MARICOPA ASSOCIATION OF GOVERNMENTS INFORMATION SUMMARY... for your review

MAG 208 Small Plant Review and Approval for the Proposed Preserve at Goldfield Ranch Water Reclamation Facility

Figure 1: Potential overland flow path from WRF to Verde River

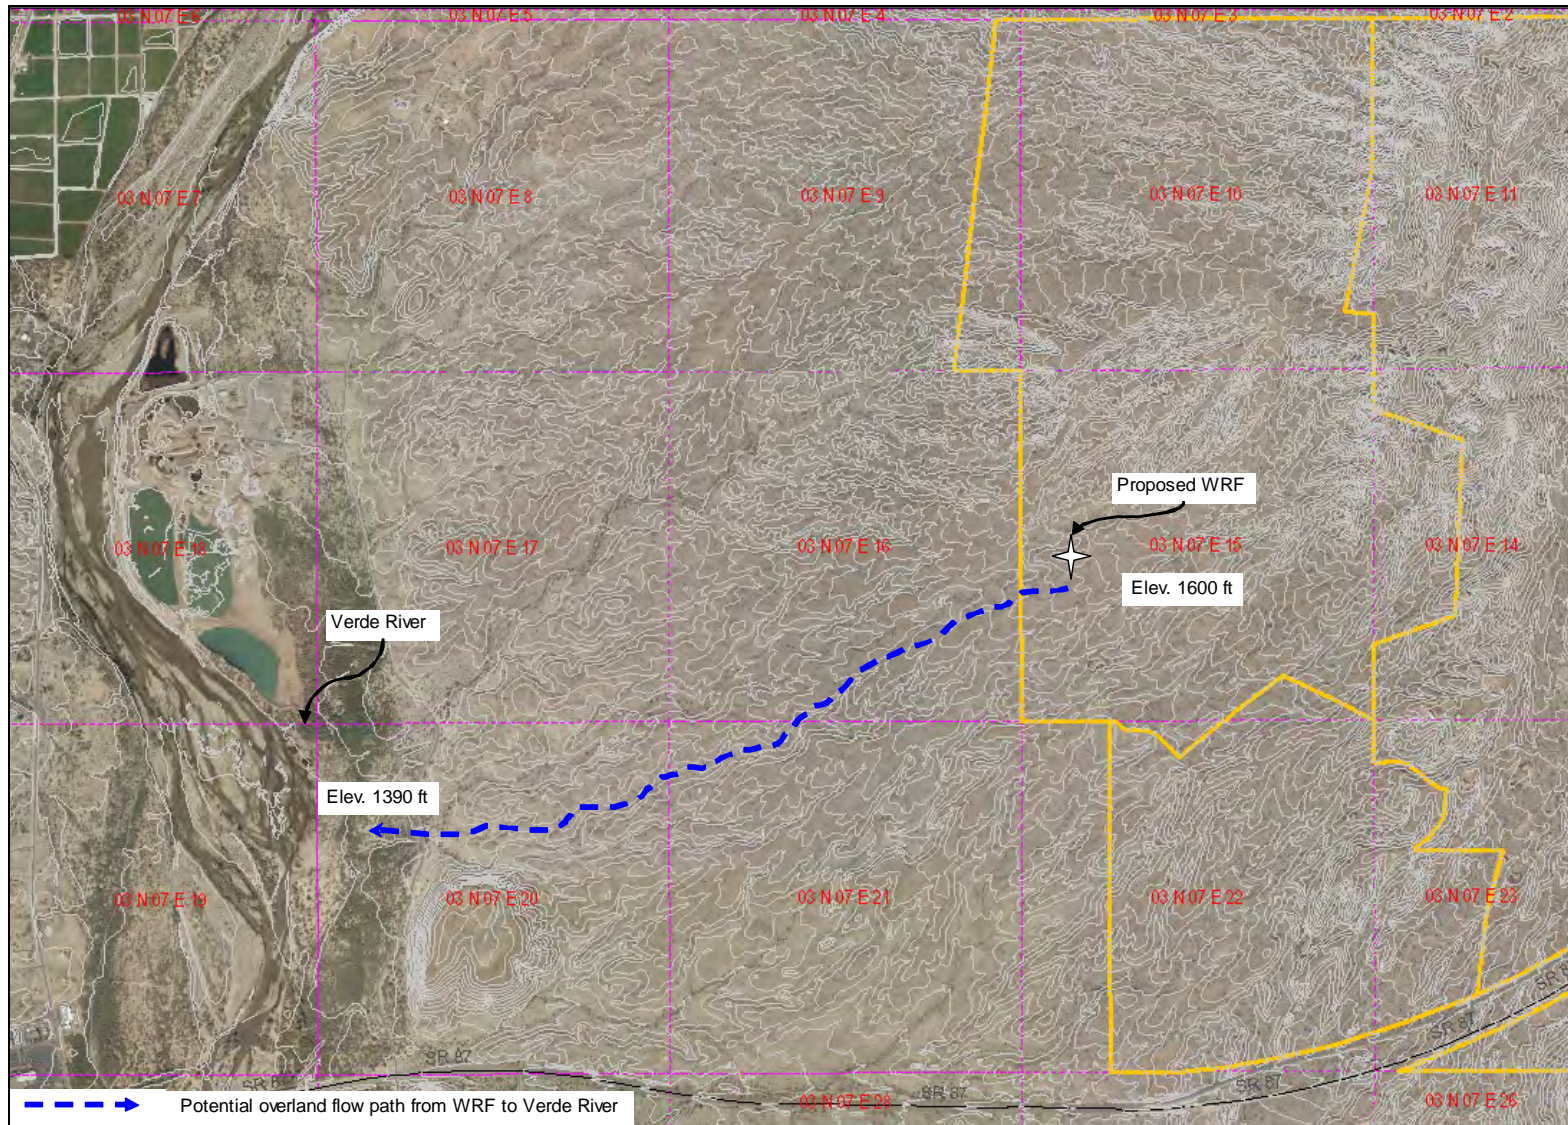
Additionally, planned discharge of unusable treated wastewater is to the aquifer below the facility, which is near the Verde River (within 2.5 miles). Based on review of hydrogeologic information, direct connection of the aquifer to the subflow of the Verde River is not conclusive. Therefore, future review of the reclamation facility plans by ADEQ may necessitate the inclusion of surface water quality standards in an APP.

Fourth, it is enveloped by sensitive habitat, a Native American community, and the Tonto National Forest, and will likely never be included in an MPA within the county. In comparison to the Small Plants identified in Section 3, the responsibility for this plant will initially and likely always be a CID. Based on the factors identified above, the plant and associated sewage collection facilities may require sophisticated technology, operation, and attentive control, and should be sized to manage the wastewater from the entire area of private and developable land. Additionally, operation, maintenance, and replacement costs will be significantly higher per service connection than the typical wastewater system, which may be difficult for a CID to continuously fund.

Tribal Comment and Response

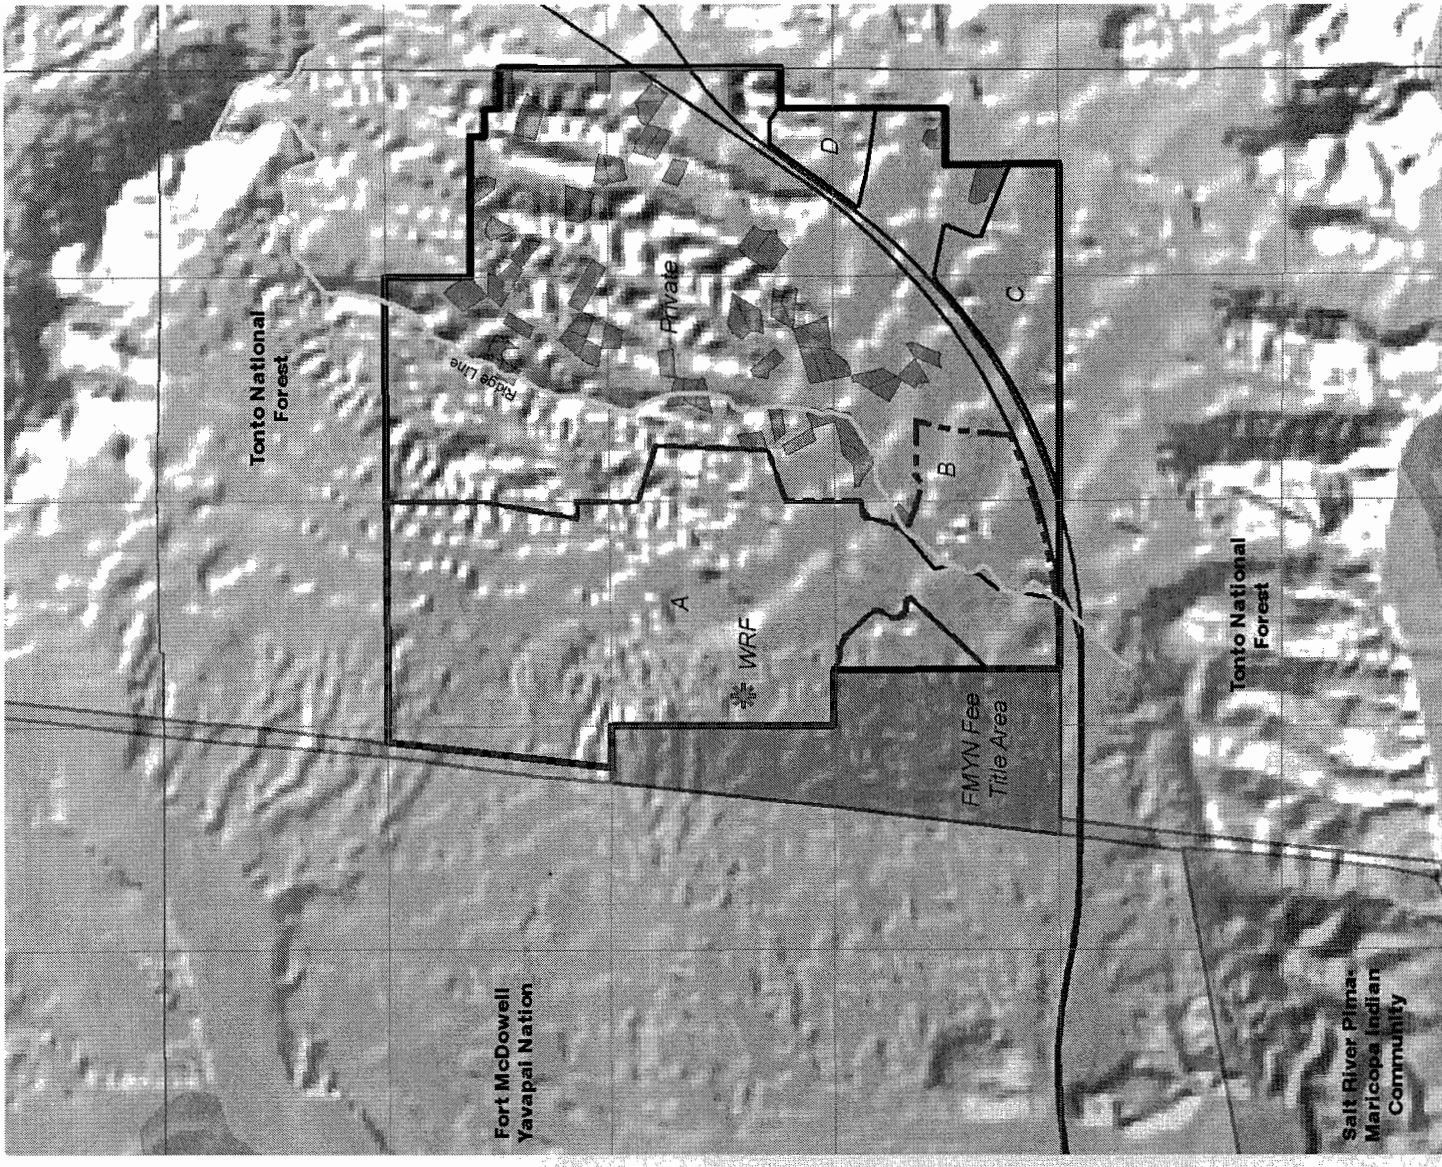
- Comment: Clay layer does not confine the upper and lower aquifer and thins out at the edges
- Response:
 - Water quality concerns addressed irrespective
 - Well tests performed on site show aquifer is confined
 - Additional investigation is ongoing
 - Reference materials supporting presence of confining clay layer (playa deposit)

Figure 3. Probable distribution of playa deposits (informally called the Pemberton Ranch Formation) in the Lower Verde River valley.

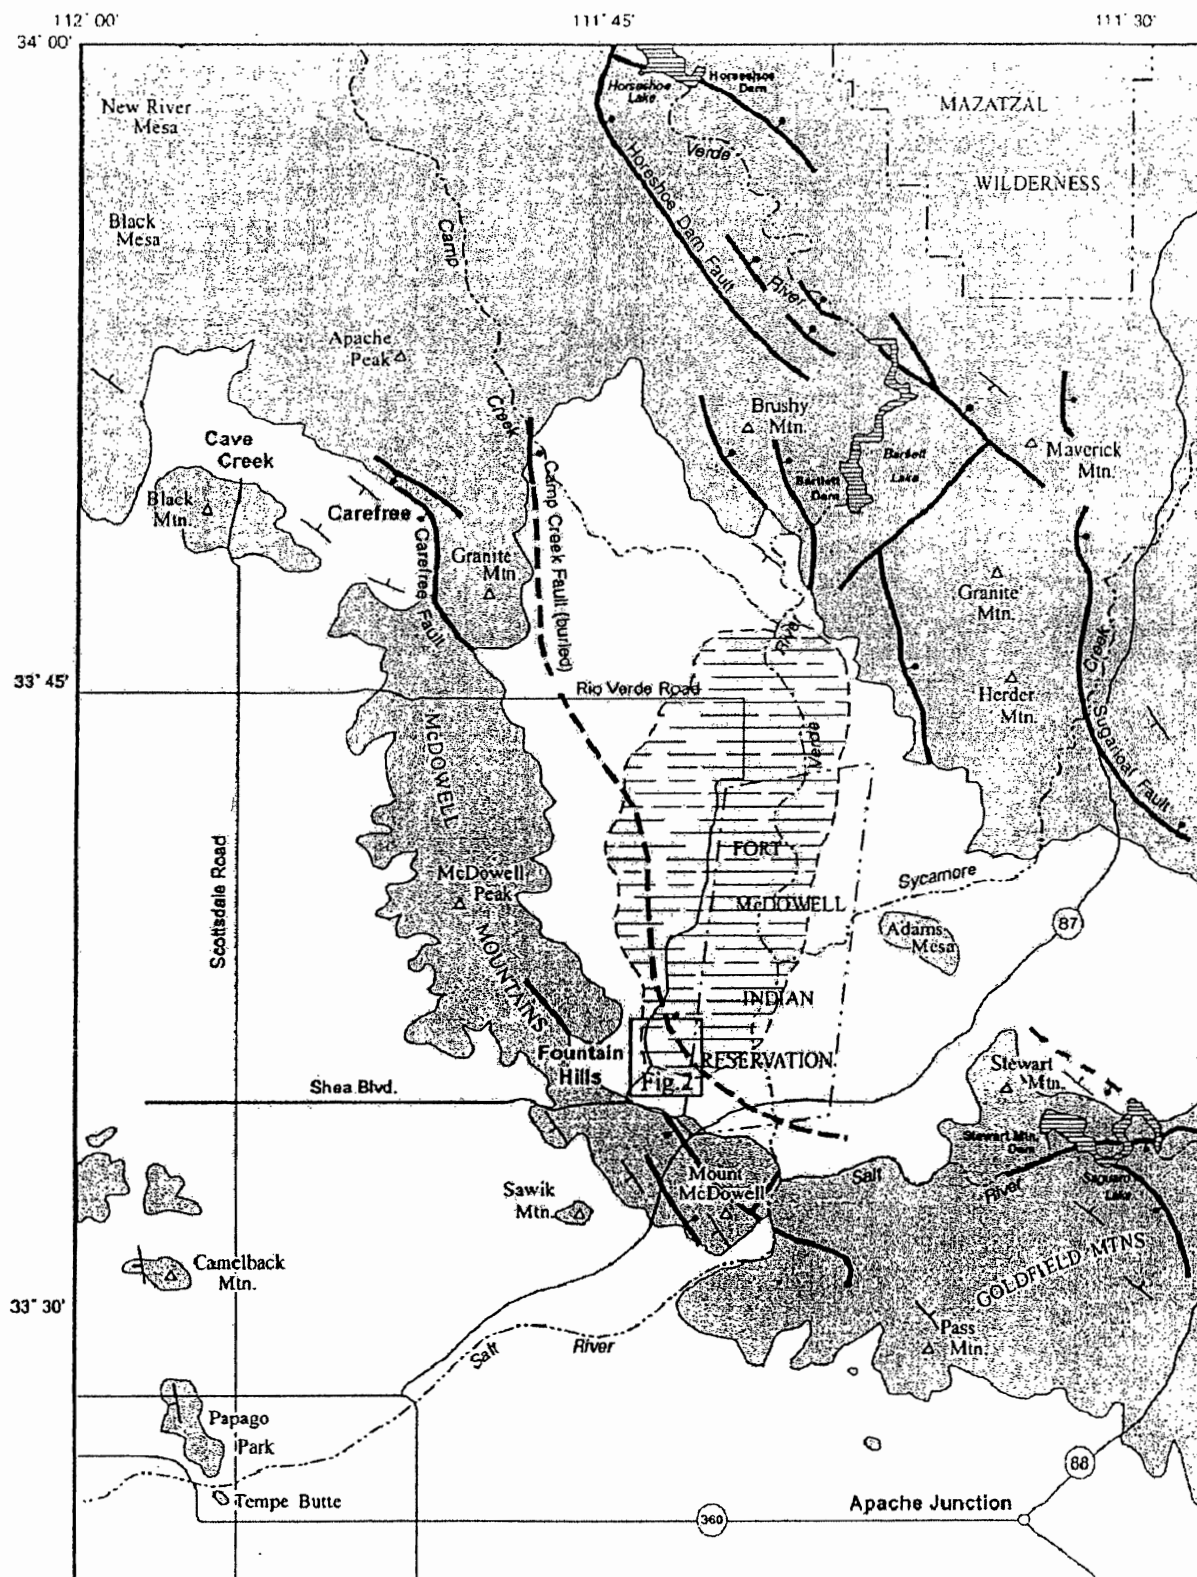
After reviewing the applicant's hydrology report used to support its Application of Analysis of Assured Water Supply, a report by Skotnicki and others (Arizona Geological Survey) and the geologic logs for sixteen wells in the vicinity of The Preserve, it is SRP's opinion that the playa deposit does not underlie the entire basin, or the entire property in question. Figure 3 of the Skotnicki report (attached) shows the eastern extent of the playa (horizontal hatched area) to terminate along a north-south line within the Fort McDowell Indian Reservation. SRP conducted its own review of 16 well logs to better define the extent of the playa and believes that it extends into The Preserve, but only into northwest corner of the property. Of the sixteen wells reviewed, only two encountered clay. There were no clay deposits in the other thirteen well logs. That leads SRP to conclude that the applicant's argument that the playa forms a barrier is flawed, and that there is a hydraulic connection between the aquifer and the subflow of the Verde River.

Tribal Comment and Response

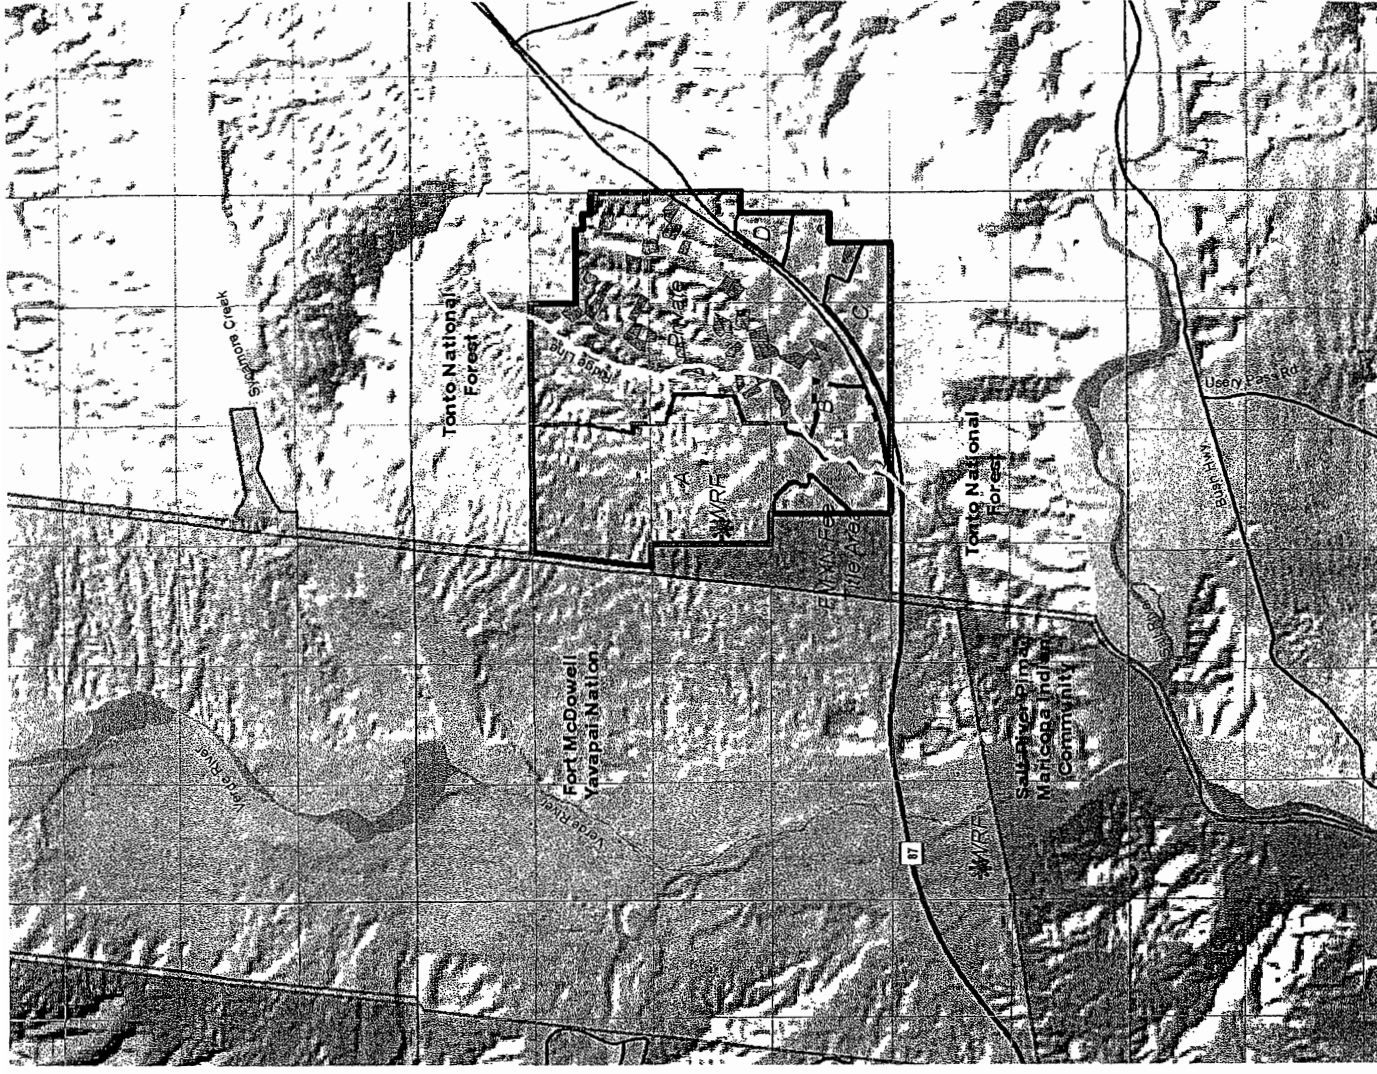
- Comment: Include Parcels C and D
- Response:
 - Distance, topography, jurisdictional waters and State Route 87 constrain the feasibility of serving these parcels
